Project Name: Kiowa Creek Recycling Facility  
Case Number: USR25-001  
Parcel No.: 2067-00-0-00-372  
Variance Letter: #2

The Arapahoe County Technical Review Committee (TRC) and Southeast Metro Stormwater Authority (SEMSWA) met on December 17th, 2025, for a regularly scheduled meeting to discuss the Kiowa Creek Facility Use By Special Review to review and reassess the additional documentation and discussion of alternatives for distribution of stormwater and the alternative outlet structures from Variance Request Memo #1. The request and justification are described in detail in the attached Variance Response Memo provided by THEngineering, LLC., and are summarized here:

RE: USR25-001 Kiowa Creek Facility, E 1/2 of the E 1/2 of the NW 1/4 Section 12, Township 5S, Range 67W, of the 6th PM, Arapahoe County, Colorado, Parcel no: 2067-00-0-00372

Photo 2, Outlet structure as proposed.

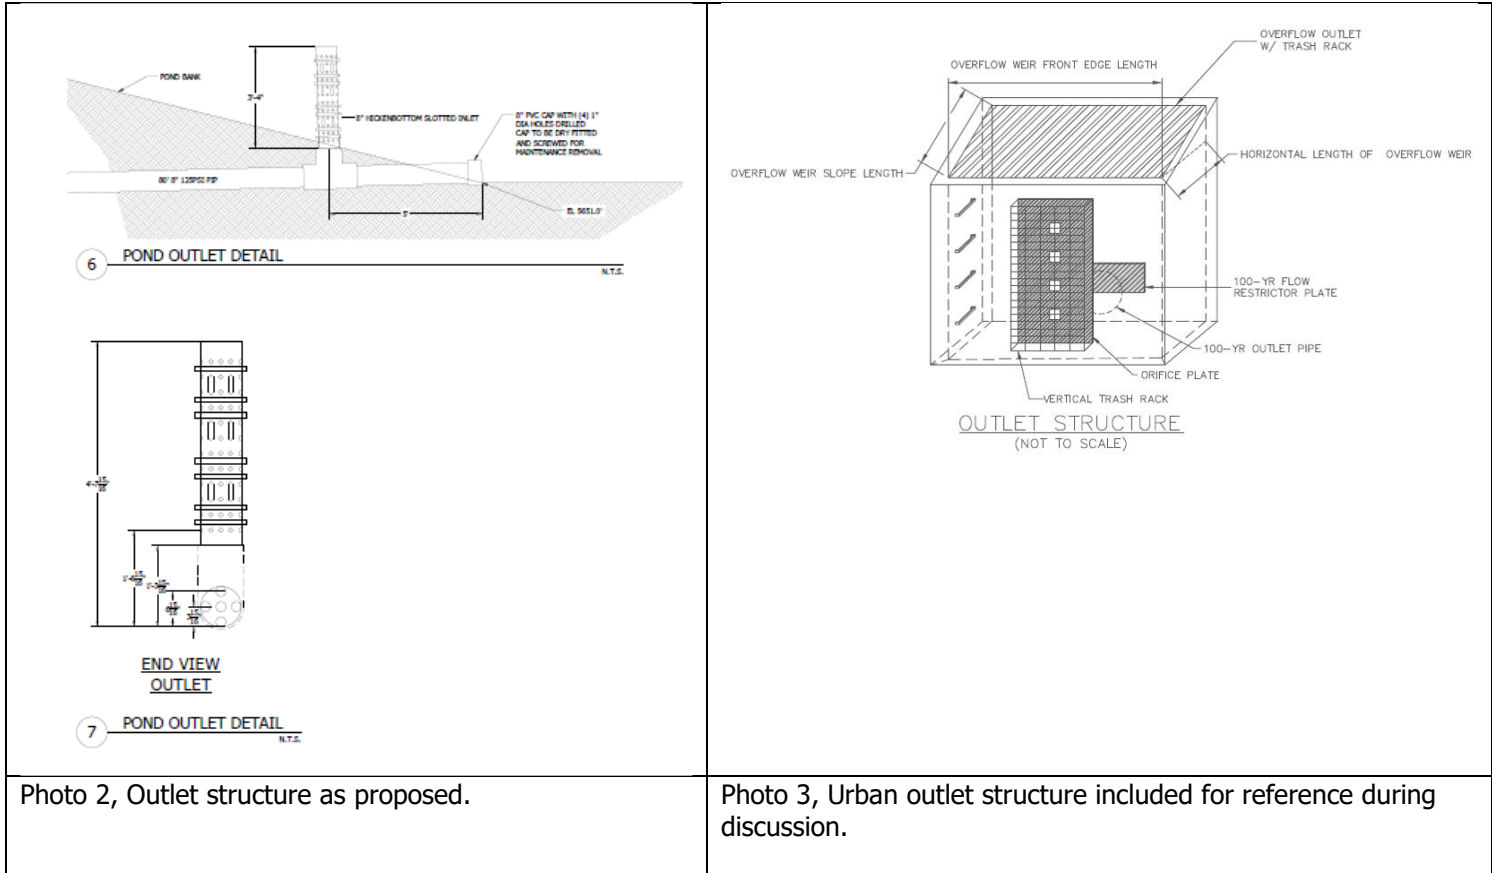
- b. The proposed changes to the outlet structure are acceptable to TRC:
  - i. Use of an 8" PVC outlet pipe instead of an 18" RCP pipe.
  - ii. Use of an alternative trash rack based on the need to keep the pipe system charged and prevent finer composting debris from entering the outlet structure.

It is my understanding that the pond outlet works is the main item of concern by the TRC. The original design of a Hickebottom outlet provided an off the shelf solution that provided screening for debris and is still my preference. This outlet design allowed for closed conduit to the gated pipe with readily available fittings. If the TRC would rather see an outlet structure that is more consistent to what you are used to seeing in the urban environment, I do believe we can design a structure that meets that criteria and still allows us to use pond head to pressure pipe. Special concerns need to be taken into account for screening the runoff since the predominate feedstock at this site is ground green waste. This feedstock will be couple inches long and float and highly likely to transport off of the composting site to the runoff pond. These ideas can better be discussed in meeting with TRC to determine what meets site constraints and TRC's expectations.

We ask for you to grant us a variance to allow us to use the proposed outlet structure as designed or help confirm a design that will meet site constraints and TRC's expectations.
